# CARROLL COUNTY POND - SAND FILTER POND WITHOUT RISER PRINCIPAL SPILLWAY PROFILE MODIFIED FOR 2' FILTER MEDIA R/R PRACTICE

73 (AMENDED)

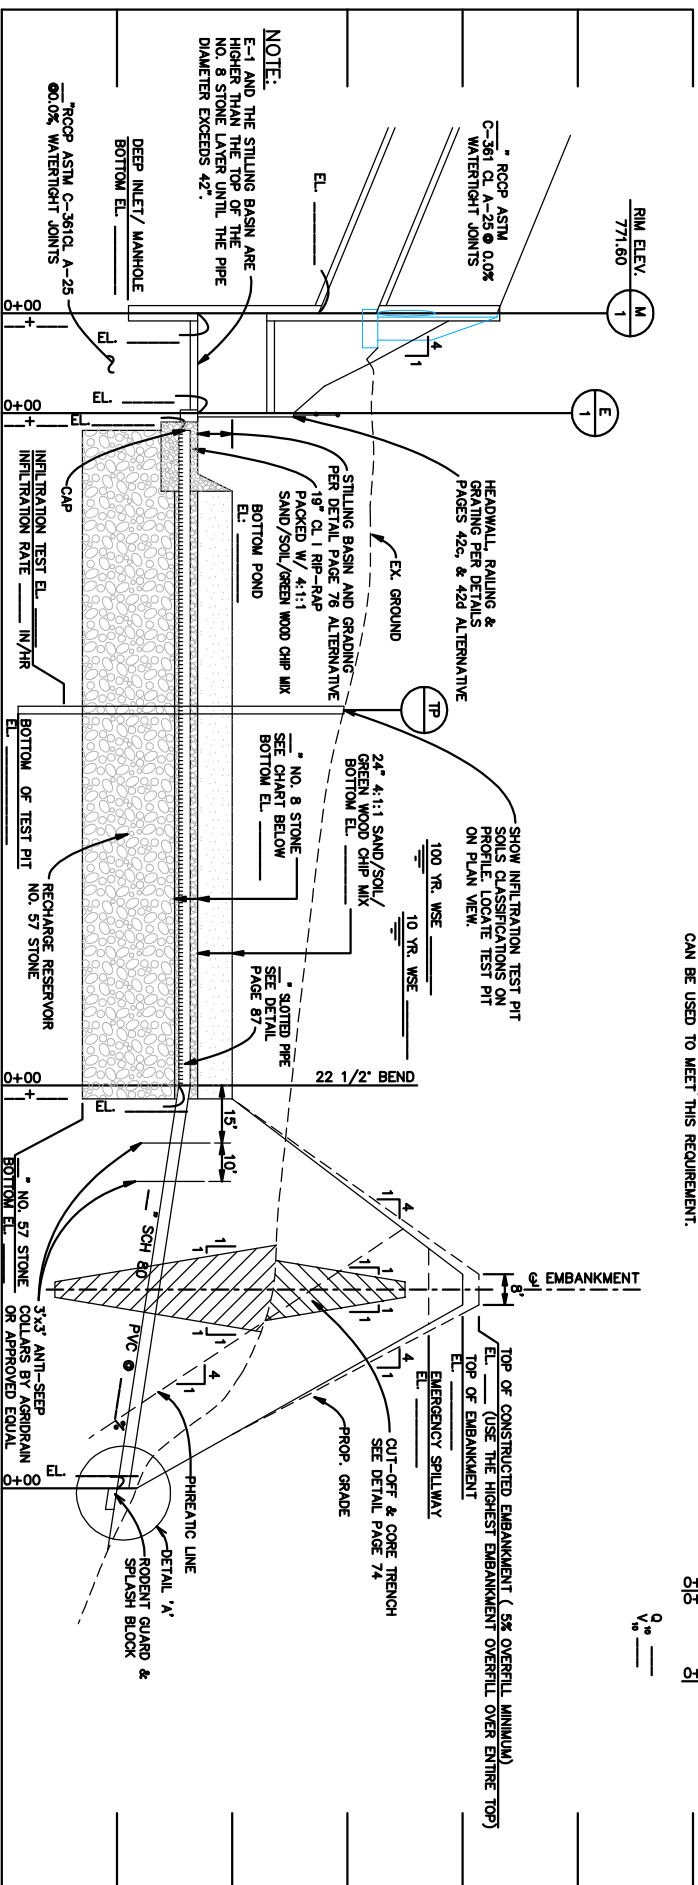
REVISED FOR R/R DESIGN

Martin B. Covington III, PE  
 SWM Program Engineer  
 DISTRIBUTED FOR COMMENT MAY 3, 2010  
 COMMENTS RECEIVED AT C.C. SURVEYORS  
 MTG. NOV 20, 2013. REVISED TO ADD CHART  
 EFFECTIVE DATE: MARCH 20, 2014

**VERY IMPORTANT:**  
IF THE UNDERDRAIN DISCHARGES INTO THE STREAM BUFFER  
V<sub>50</sub> MAY NOT EXCEED 2 FT/SEC AT THE EDGE OF THE BUFFER  
PER C.C. WPA IV CSB2. A 10 FT FLAT SECTION OF  
OVERSIZED UNDERDRAIN, STANDARD REDUCER AND BEND  
CAN BE USED TO MEET THIS REQUIREMENT.

STONE DEPTH PER UNDERDRAIN DIAMETER	MINIMUM NO. 8 STONE DEPTH
4"	10"
6"	14"
8"	18"
10"	22"
